Revise to Preliminary/Final Drainage Report for
Riverbend Crossing Filings No. 1 and 2.

MASTER DEVELOPMENT DRAINAGE REPORT FOR RIVERBEND CROSSING AND FINAL DRAINAGE REPORT FOR RIVERBEND CROSSING FILINGS NO. 1 AND 2

SEPTEMBER 2018

<p>PO BOX 692 DIVIDE, CO 80814 (719) 426-2124</p>	PREPARED FOR: AVATAR EQUITES 6800 JERICHO TURNPIKE SUITE 120W, #204 SYSOSSET, NY 11791	RIVERBEND CROSSING		SCALE:	DRAWN BY:
		EXISTING FLOODMAP EXHIBIT		1"=500'	DLM
				JOB NUMBER	DATE:
				17-114	XX/XX/XX
				SHEET	
				1 OF 1

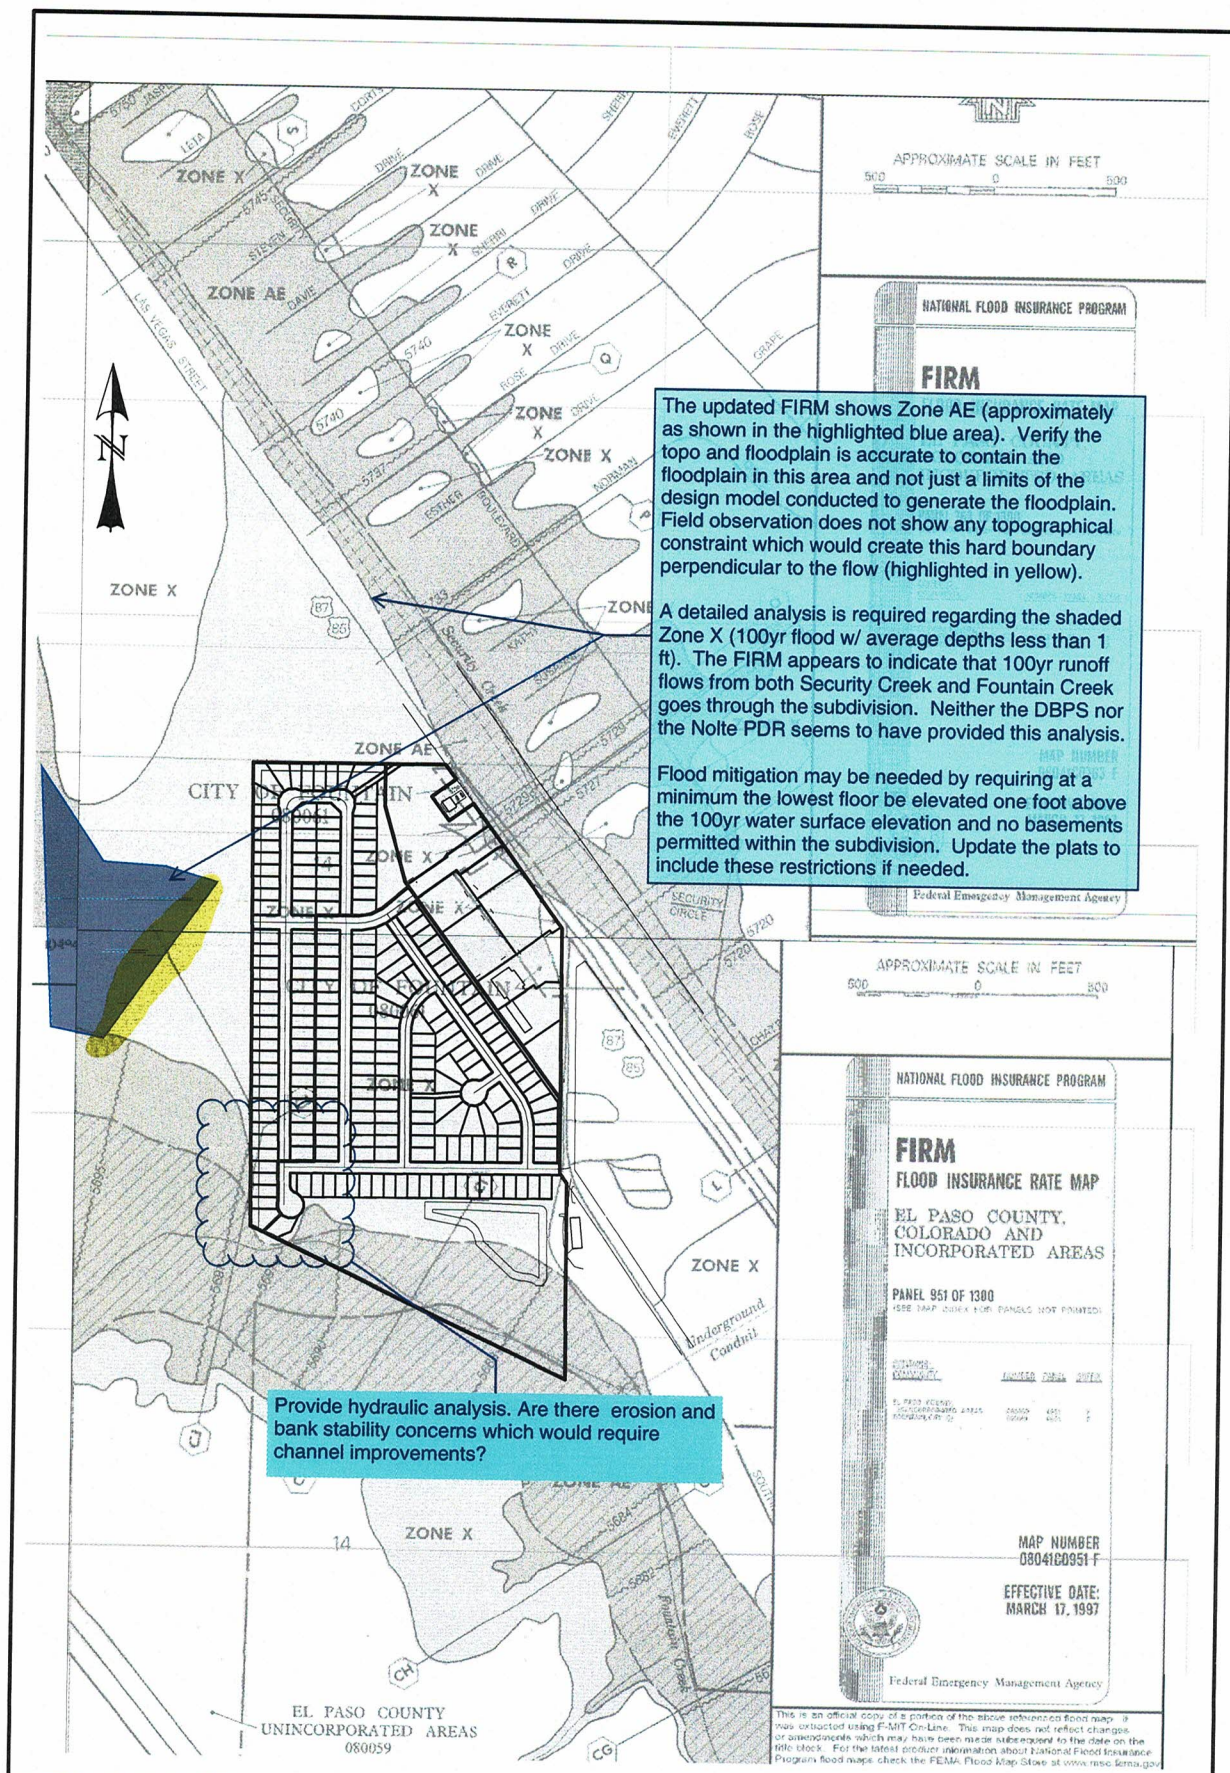
Update. Shaded Zone X

ADDED

RIVERBEND CROSSING
EXISTING DRAINAGE CONDITIONS

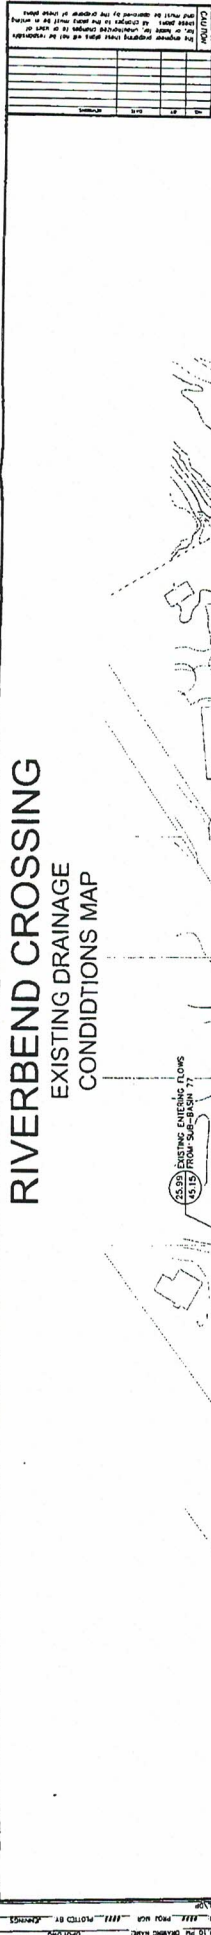
These off-site flows does not appear to have been accounted for in the proposed condition.

EXISTING DRAINAGE BASINS 75, 76 AND 77 WERE TAKEN FROM THE APPROVED LITTLE JOHNSON DRAINAGE BASIN PLANNING STUDY, DATED: APRIL, 1988

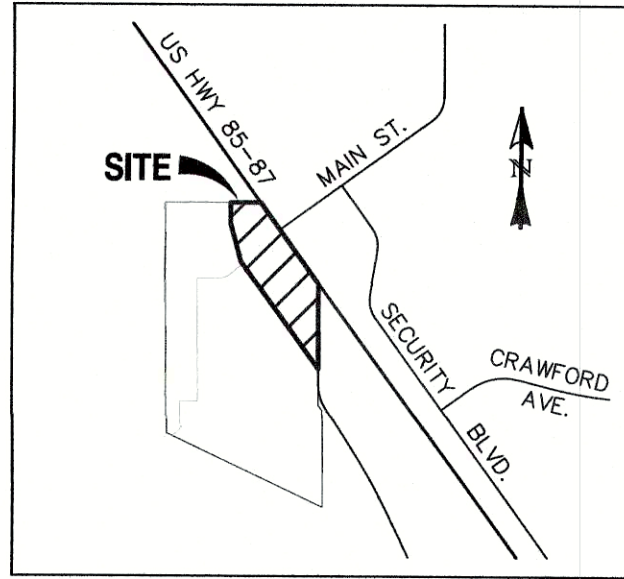
The Nolte PDR identified the need to provide toe/slope protection. The Nolte report noted that the analysis/ HEC-RAS modeling was preliminary in nature. Final hydraulic analysis, design and construction is required.

Both the Nolte PDR and this report's narrative identified the need for a drainage swale along the western boundary. This drainage swale must be located within a tract.

County GIS shows this would drain back into the subdivision at the southwest corner

Show BFE. The FEMA BFE appears to be from 5691 to 5688. The pond appears to be submerged during the 100yr storm event negating the effectiveness of the detention pond.

Relocate the FSD pond outside the 100yr floodplain. The pond must be above the BFE. If the outlet structure is located below the BFE then tailwater effect must be analyzed.

Revise the contours or place drainage swale in a drainage easement. Revised to 'N' lots.

Provide maintenance access path from a public street and a ramp to the bottom of pond.

Include Provide the riprap sizing calculation.

Add on the legend what this symbol represents.

Per DCM Chapter 11 Section 11.3.3 the top width of the top of embankment shall be a minimum of 12 feet. TOP WIDTH MIN 12 FT. 27' ~ 53'

Provide access around the perimeter of the EDB. PROVIDED

Revise Basin B14 boundary. The inlets at the side streets are in a sump condition which continues the cross slope of Booker Blvd down to the inlets. The crosspans will not be able to convey runoff through the intersections. Runoff will turn to the north and into the inlets. Revised w/ Main Pond BETWEEN 10 LOTS AND CROSS-PAD

Proposed C&G and sidewalk must extend to the proposed intersection. NOTED

Indicate the emergency overflow path for the Commercial sub-basin and update to discuss in the narrative. ADDED

Revise the sub-basin. Based on the contours portions of the commercial development drains into the residential development via Main Street.

The inlet calculation for basin B7 indicates a 10' inlet. Revise accordingly. Revised

Flows listed for design point 10 do not match the calculations or the narrative. Revise. Revised

1. Make the basin boundary darker for clarity.
2. If applicable, update hydraulic calculations to incorporate the additional 100yr offsite flows from Security Creek and Security Creek going through the shaded zone X. A LOW MODIFIED 100-YR CROSS-ROAD CUL. OF 85' BT
3. provide contour labels.
4. Include a pond summary table in the proposed drainage map. ADDED

100-yr PROTECTION INCLUDED

16' BOTTOM WIDTH SWALE @ 0.5% DRAINAGE SWALE ADDED

FLOODPLAIN SHOULD HAVE BEEN FROM 'F' SERIES MAP TO EFFECT AT TIME OF SUBMITTAL. MAPS HAVE BEEN REVISED WITH NEW FLOODPLAIN. BASE FLOOD ELEVATIONS HAVE BEEN ADDED.

A PORTION OF THE POND REMAINS BELOW THE BFE. EXCESS CAPACITY ABOVE BFE WAS DESIGNING INTO POND. THE CAPACITY ABOVE THE BFE EXCEEDED 100-YR VOLUME. INLET CONDITIONS REQUIRED ADDITIONAL DEPTH.
